The Country Club Heights Neighborhood is more than concerned with the Proposed Waypoint 5 Project that will be presented as case number ZON 20-00538 on the February 24th meeting.

Impact and Facts

To The City of Mesa Planning and Zoning Committee:

Figure 5

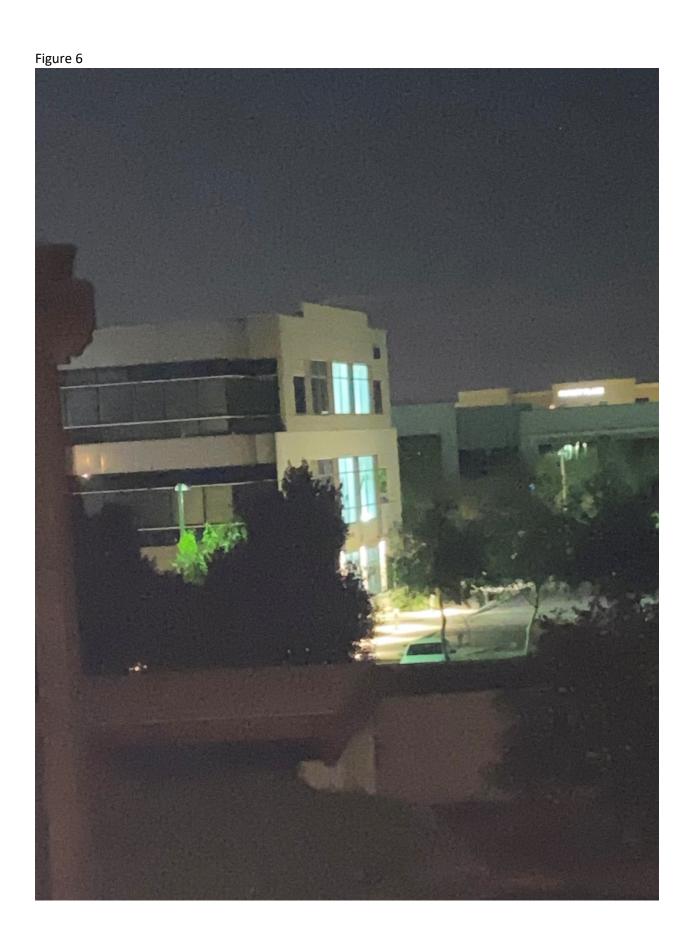
Figure 5 6:30am from 1328 W Mountain View Dr. /Winter 2020

This is taken from Boyle's lot (where they are planning to build their custom home) The lights are from Waypoint 3 & 4 Building. The building that was built without our notice.

The point is, there is lighting going on all time of the night. Why? When we addressed this to Michael Monroe and Mike Edwards on November 3rd 2020, they said they would look into this. As of 2/15/2021, we see no changes. As a matter of fact, it seemed to get worse.

Waypoint light pollution and invasion from a parking garage will be extreme.
